E8364BH85-03A

S E R V I C E N O T E

E8364BH85 PNA Microwave Network Analyzers

Figure 1: A3 Front Panel Interface Board Assy without the Bracket

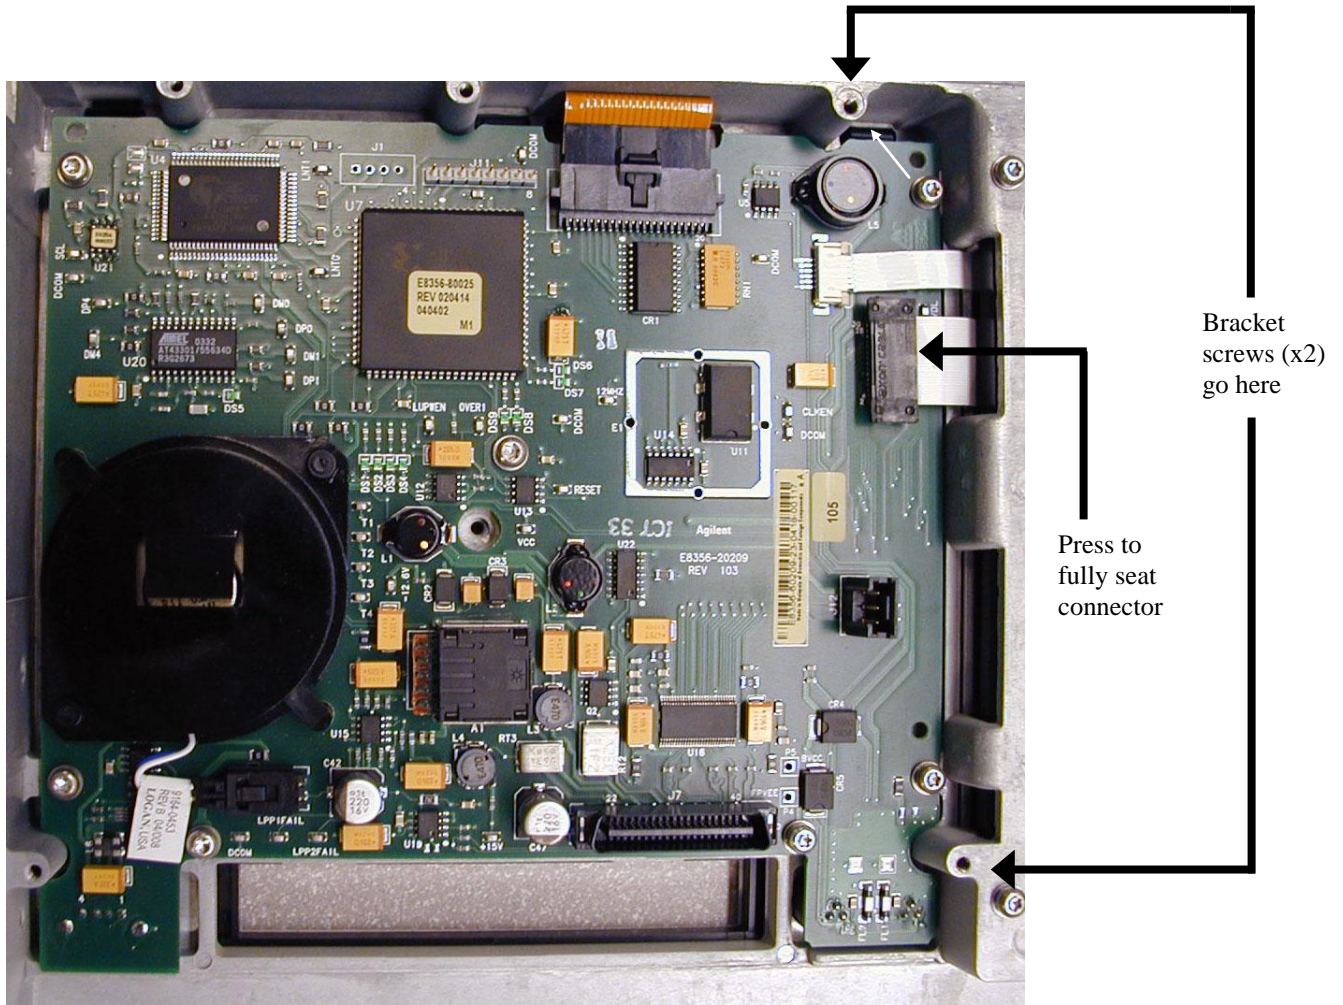
A connector of the ribbon cable (Agilent part number 8120-8409) that joins the front panel display to the front panel interface board can loosen, causing a display failure, unless a new bracket is installed. Because the failure rate has been very low, ***it is recommended that the bracket be installed only when there is an additional reason to remove the PNA front panel.***

A connector of the ribbon cable (Agilent part number 8120-8409) that joins the front panel display to the front panel interface board can loosen, causing a display failure, unless a new bracket is installed. Because the failure rate has been very low, it is recommended that the bracket be installed only when there is an additional reason to remove the PNA front panel.

1. Refer to Figure 1 in this document:
 - Press down firmly on the ribbon cable's black connector.
 - Locate the two tapped holes for the bracket screws.
2. As shown in Figure 2 in this document, position the bracket so that its holes line-up with the two holes you located in the previous step.
3. Hand-start the two screws, and then torque both to 9 in-lbs.
4. Reinstall the PNA Front Panel by following the Service Guide instructions in the "Replacement Procedure." This is located on the same page as the "Removal Procedure" used previously in step 7.
